U.S. Army Corps of Engineers (USACE)  
**NATIONWIDE PERMIT PRE-CONSTRUCTION NOTIFICATION (PCN)**

NCDOT/U-5813/UTs to Little River, UTs to Cedar Fork/US64/Randolph/44385.1.3

### Interagency Permit Drawing Package Review Meeting

**On 11/23/20 HNTB provided response to comments provided within these minutes. Those responses are shown in RED.**

PERMIT DRAWING SHEET 11 OF 19

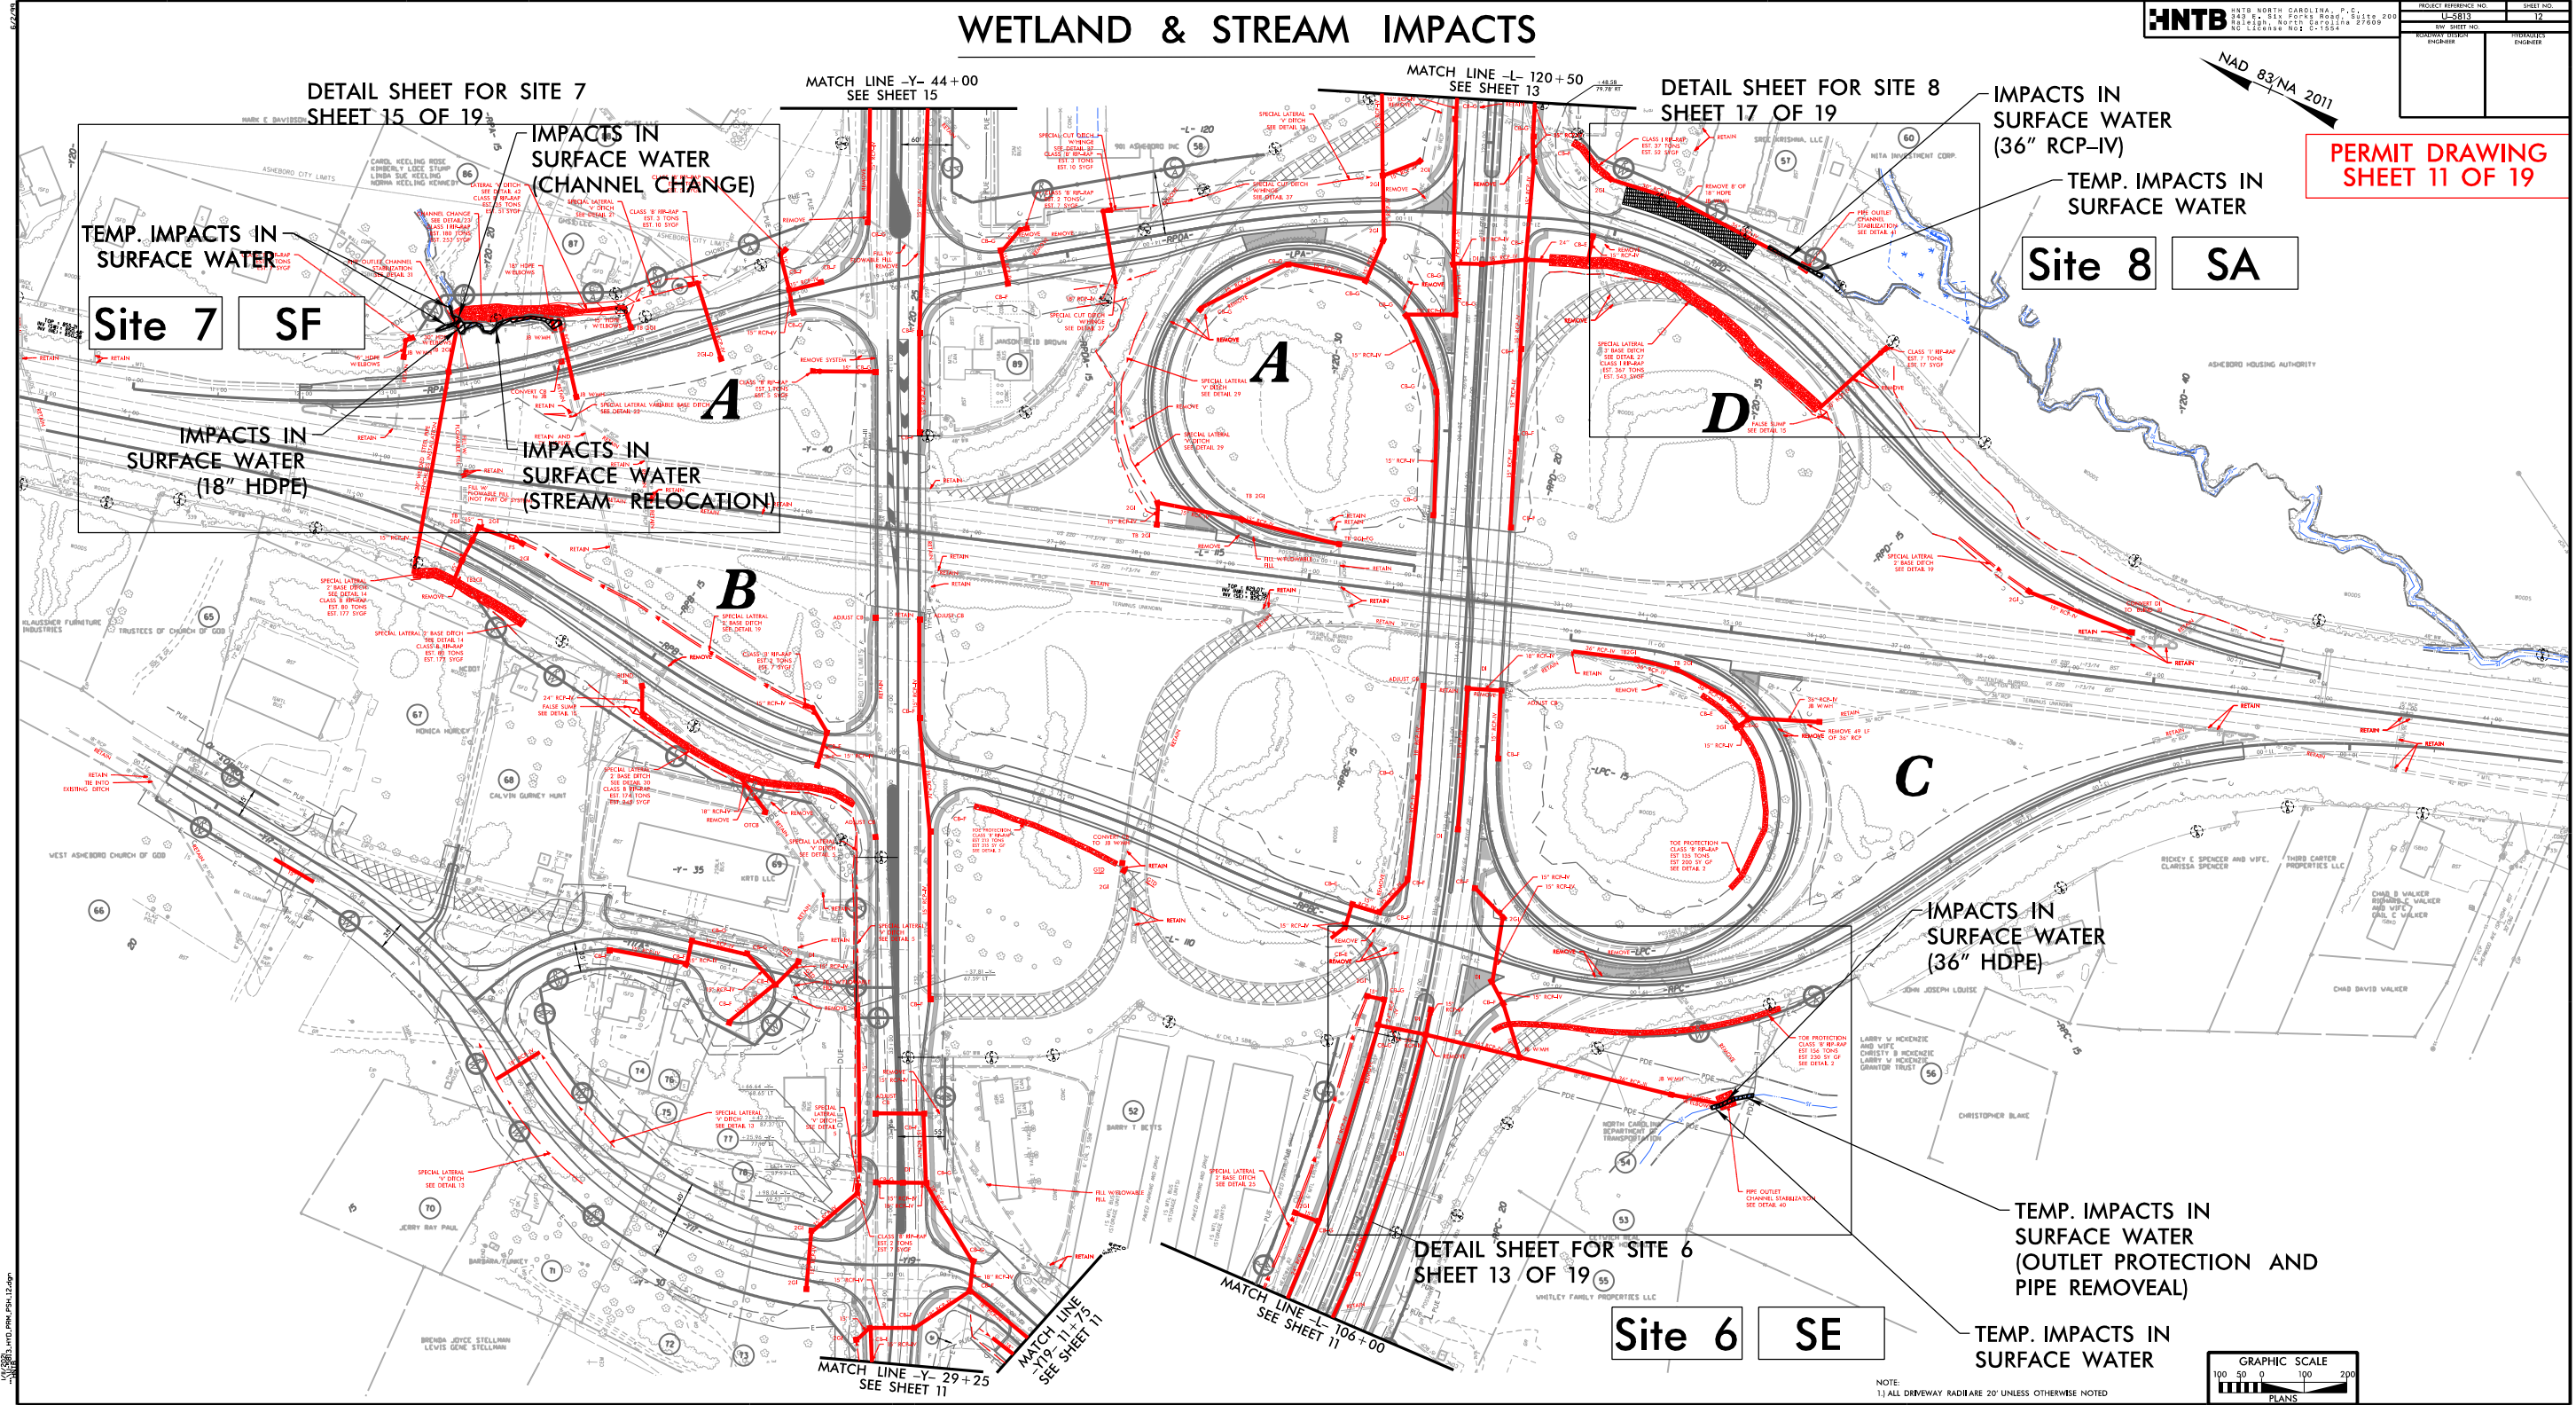
- Rob Riding asked the design team to consider other options for pipe outlets that would avoid direct untreated discharges into the stream if possible.
  - Of particular concern was the discharge directly into the proposed RCBC via a 36" RCP.
  - James Byrd advised this outlet point was chosen to minimize impacts to Parcel 20.
  - James Byrd added that in addition to the SBG that's being drained, this outlet also included runoff from line ahead that's being treated in grass swales.
  - James Byrd advised that designs in this area would be revisited as requested but added that limiting factors at this location such as existing topography and ROW constraints may dictate that current designs remain.

PERMIT DRAWING SHEET 18 OF 19

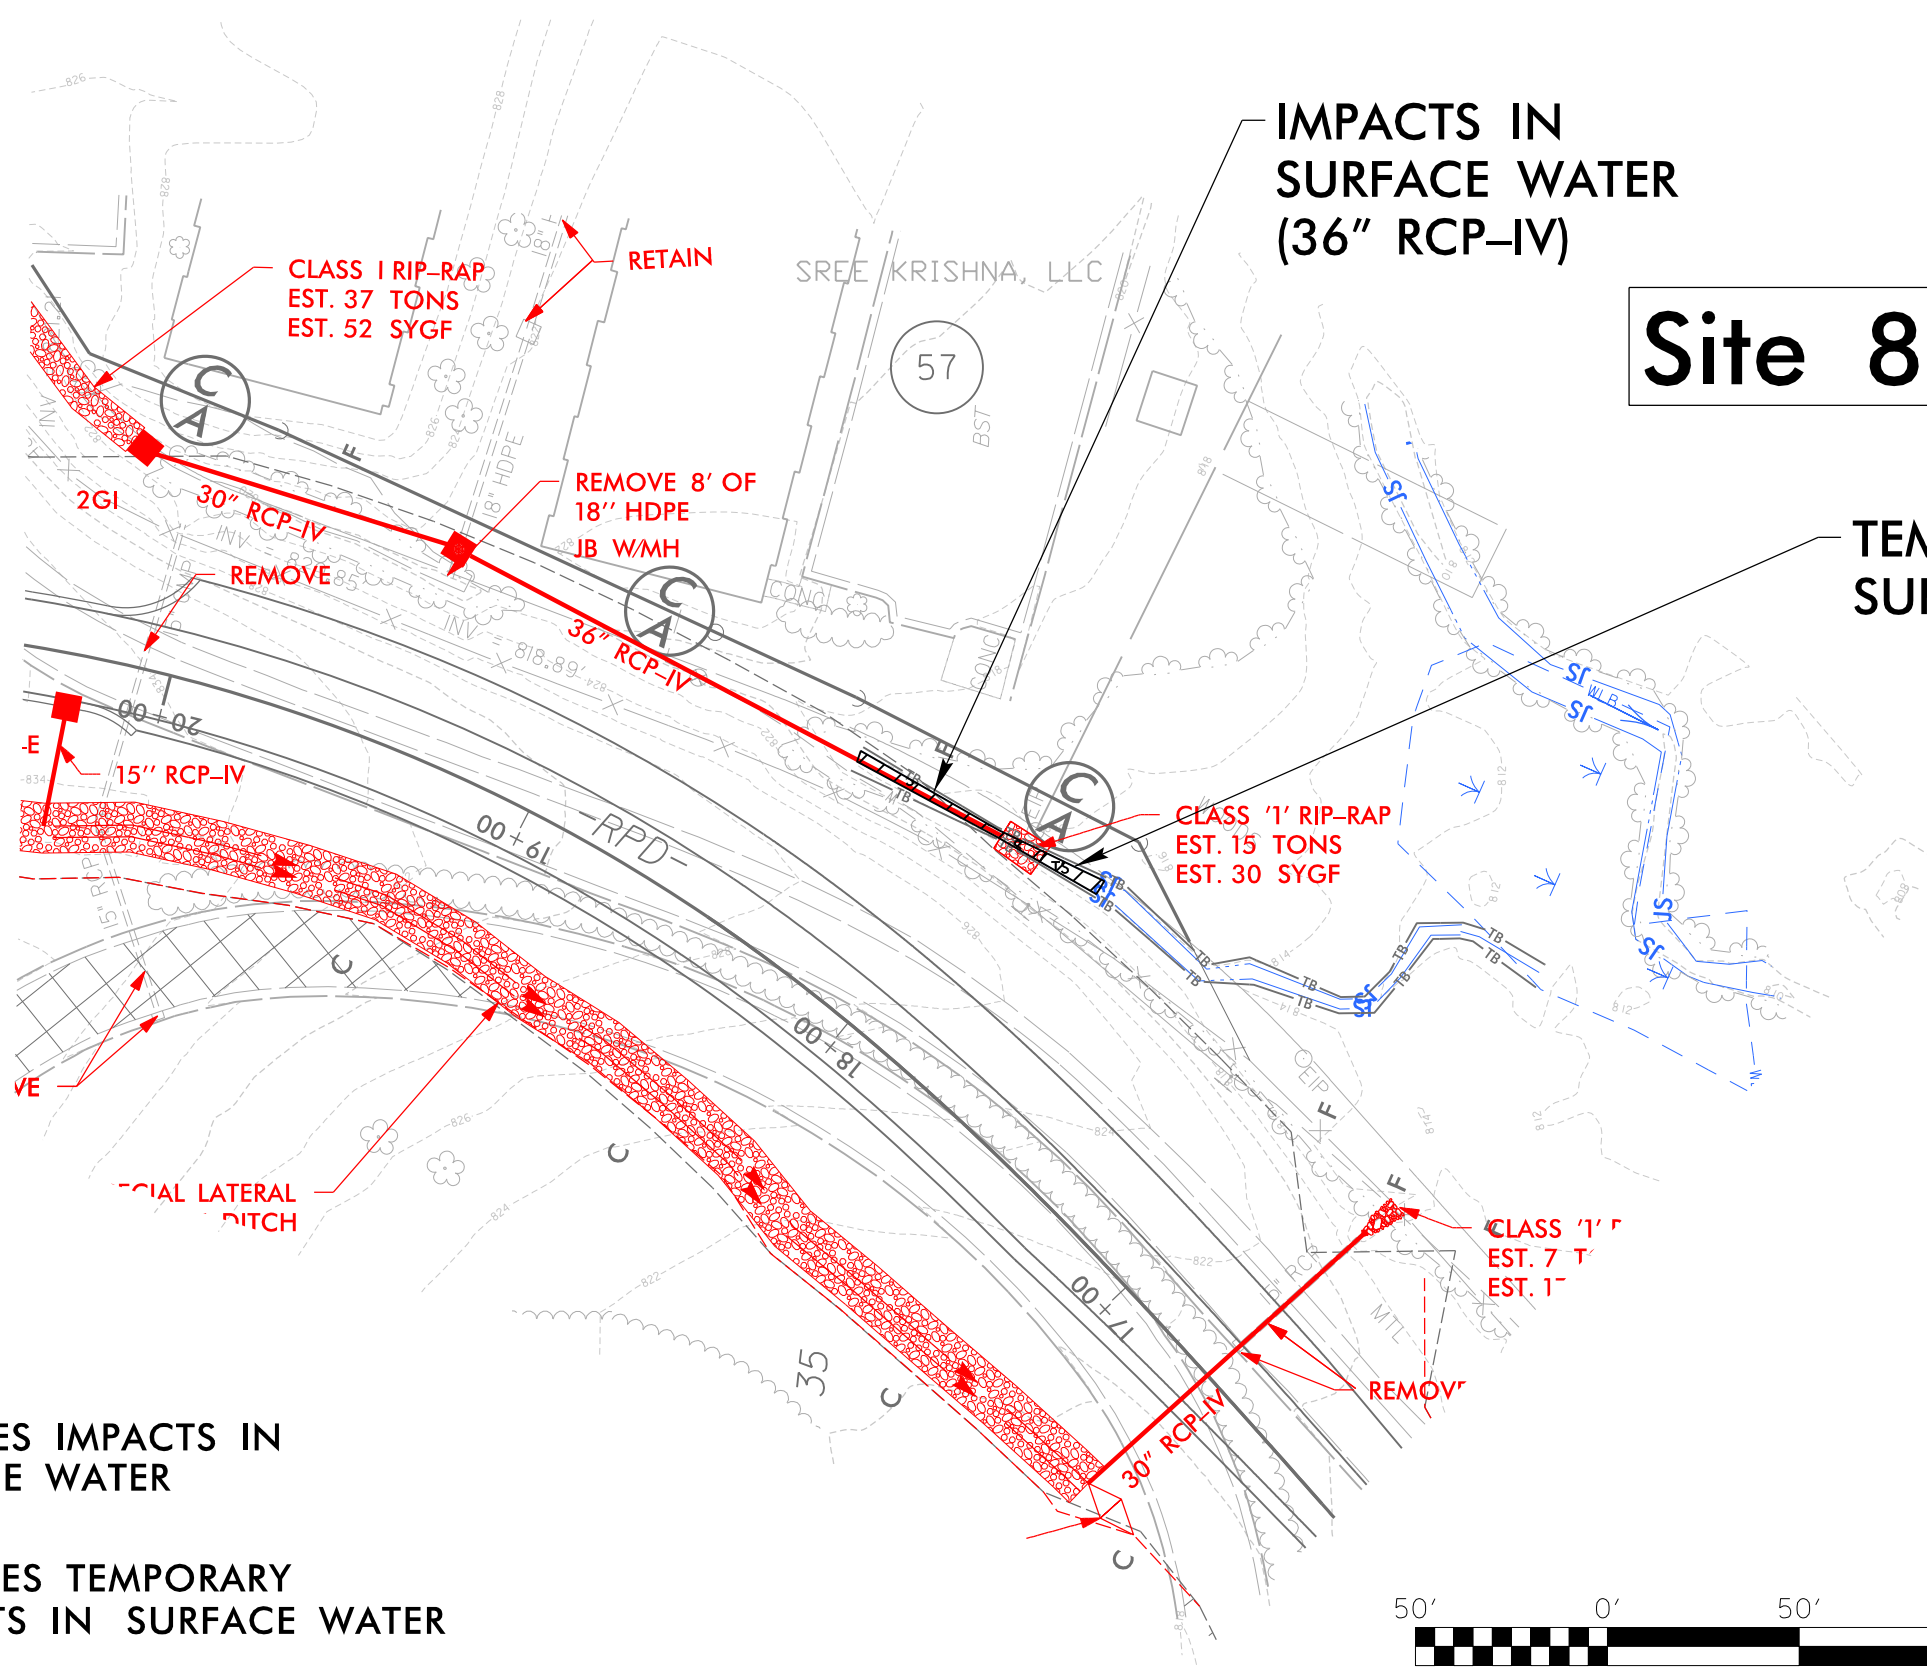
- James Byrd provided a description of the impacts at this location.
  - Proposed impacts are the result of the improvements to Ramp D.
- There were no questions or comments provided.
